HEGER DRY DOCK, INC

Re: Request for HEGER Certification of Dry Dock No. 2 located in BAE San Francisco, CA

The objective of this letter is to present the results of HEGER's design review. The review outlines the dry dock's limitations and notable structural deficiencies of the dock's current condition. The design review includes:

BAE SYSTEMS SAN FRANCISCO, CA	COMMERCIAL CERTIFICATION OF FDD #2
REPAIRS - EAST OUTBOARD WINGWALL

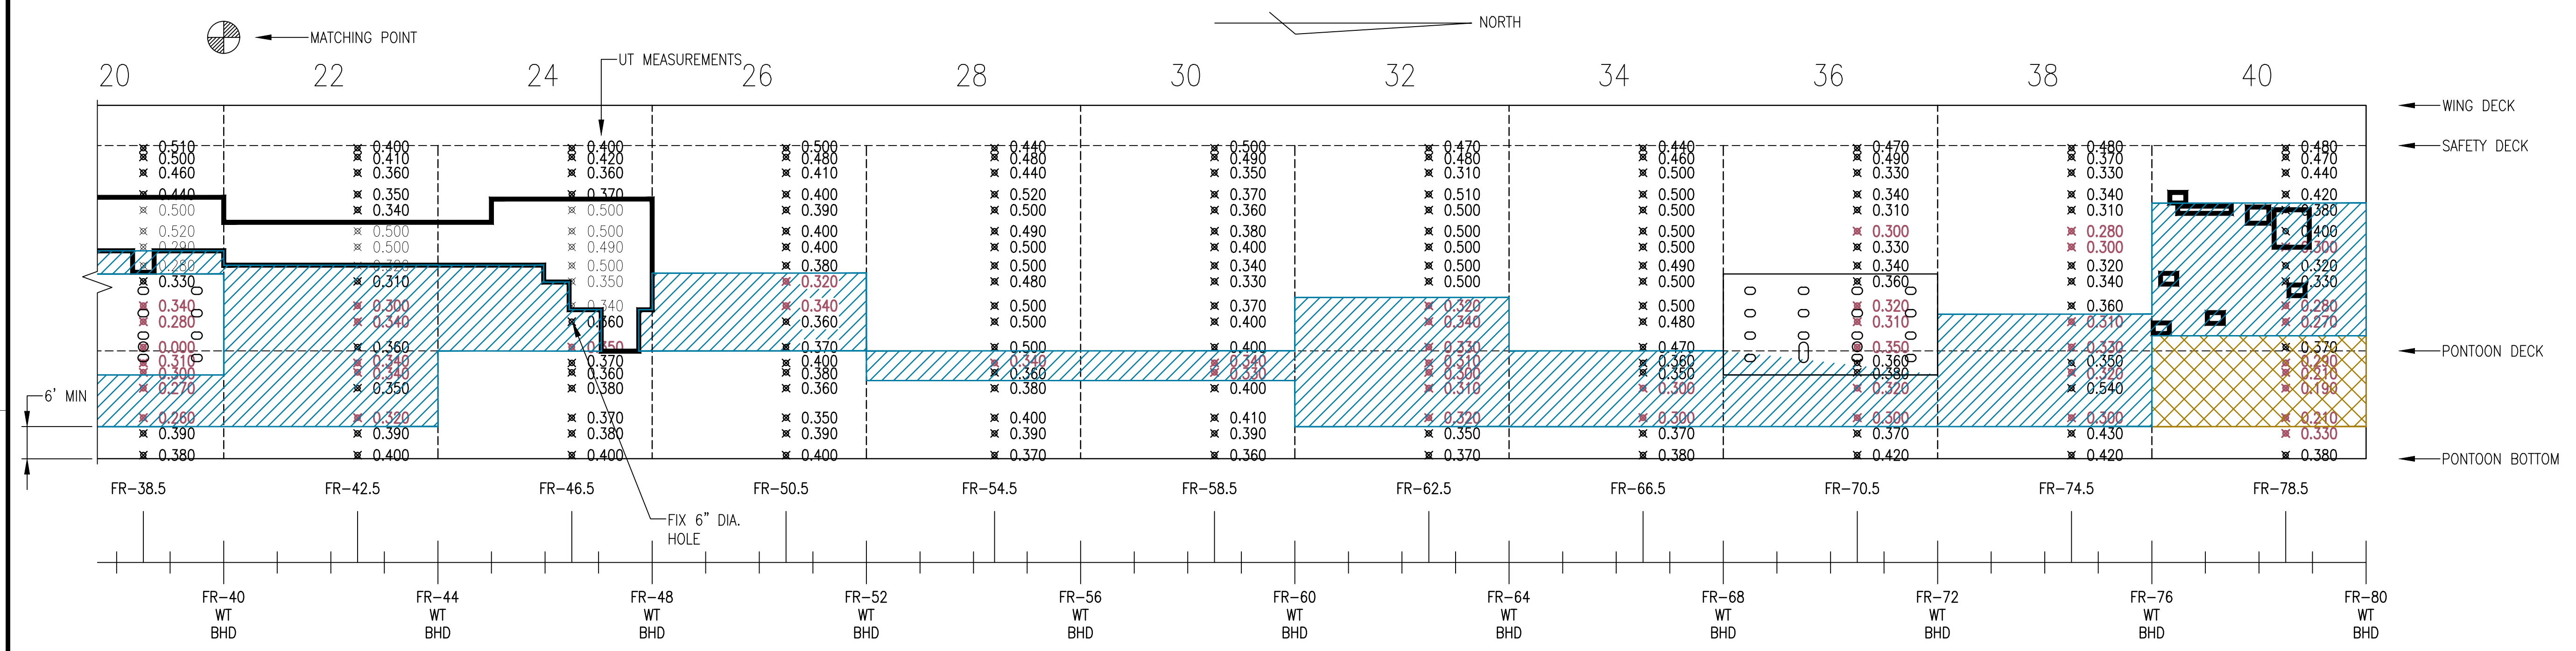
The UT survey results of the dock's external shell plating indicate areas of significant metal thickness loss. Areas of extensive corrosion were confirmed by HEGER's August 2016 visual inspection with numerous observed holes in the plating.

The majority of the external shell repairs have been made to the East and West outboard shells with about 20% of the dock's original plate panels being replaced.

HEGER's primary concern with the dock's current structural condition is the severely corroded shell plating, with number of holed-through areas. The holes, located throughout the dock, impede the watertight integrity of numerous ballast tanks and raise the following concerns:

In the drawings listed below, all areas are generally mapped out on a tank by tank basis. It is recommended the external shell in these areas be cropped out and replaced with a fabricated insert plate to properly repair the area. In the event of small isolated holes, a doubler plate may be installed as a temporary fix.

BAE SYSTEMS
 SAN FRANCISCO, CA
COMMERCIAL CERTIFICATION OF FDD #2
 REPAIRS - WEST INBOARD WINGWALL

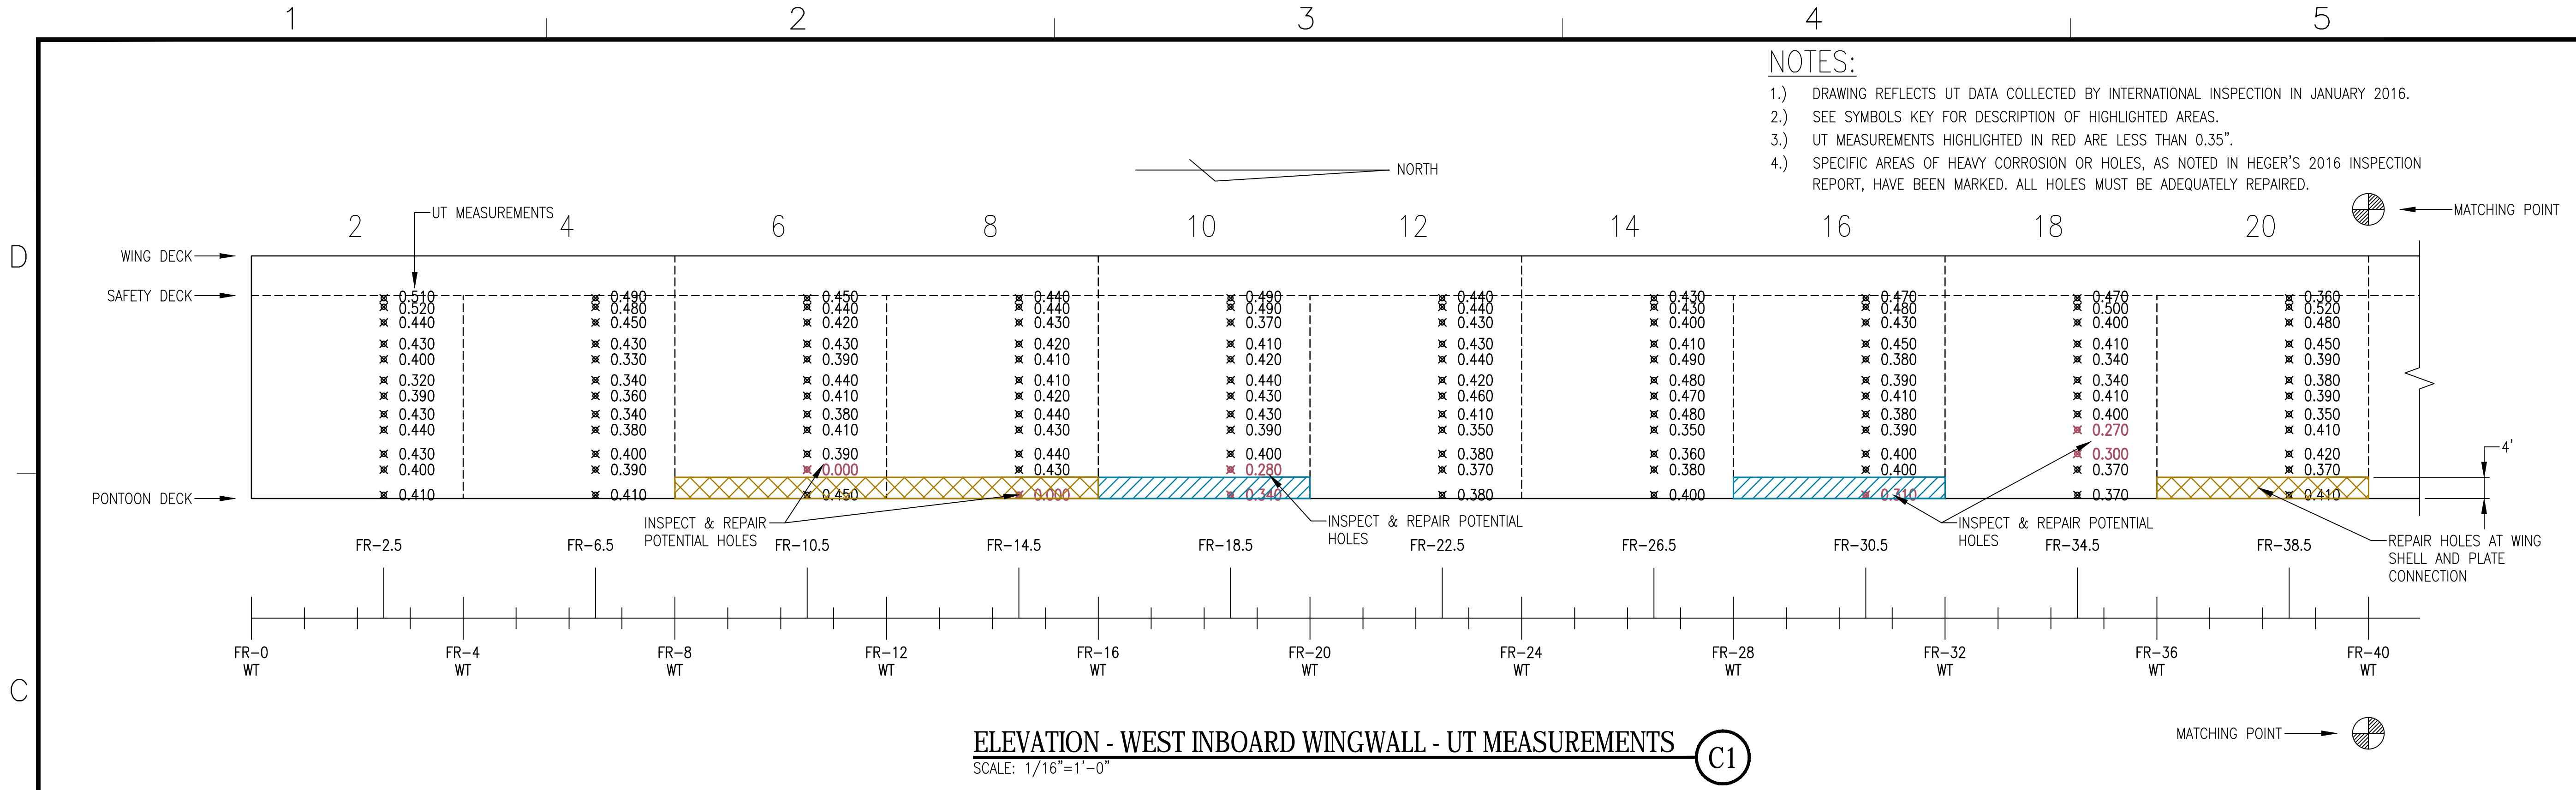
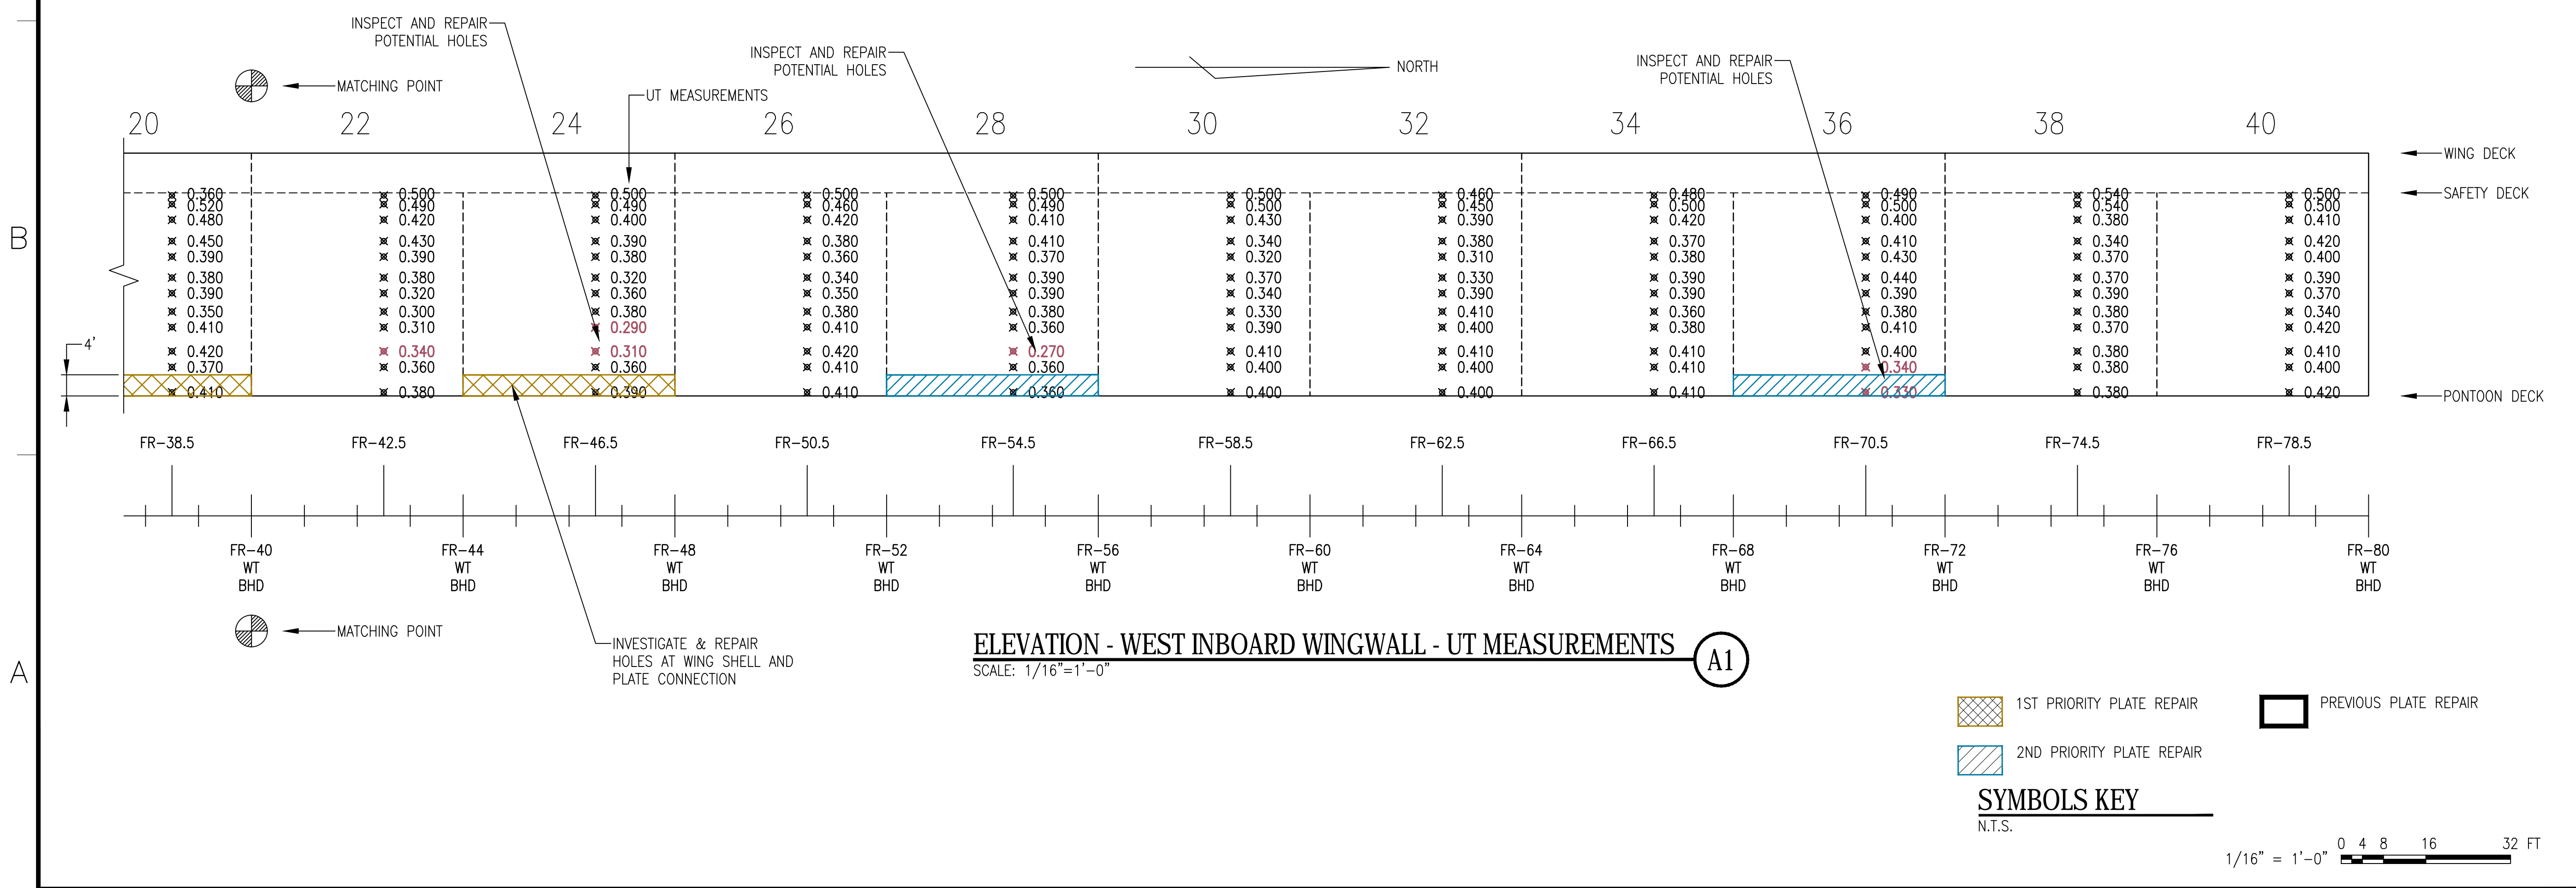
Based on HEGER's knowledge of the dock's design review, visual condition survey, and most recent UT survey, areas of the dock's structural deficiencies have been mapped out on the inboard and outboard wing shells and the pontoon deck in the drawings listed below. HEGER has assigned a Priority 1 or 2 to the areas of most structural concern.

Priority 1 areas will need to be repaired prior to HEGER certification. These areas are either heavily corroded as indicated by the dock's UT survey or contain holes or other deficiencies noted in the 2016 control inspection.

Priority 2 areas will need to be repaired before the subsequent HEGER re-certification. These areas also show signs of significant corrosion. Until the priority 2 areas are repaired, there will need to be operational restrictions regarding allowed head pressure in these areas.
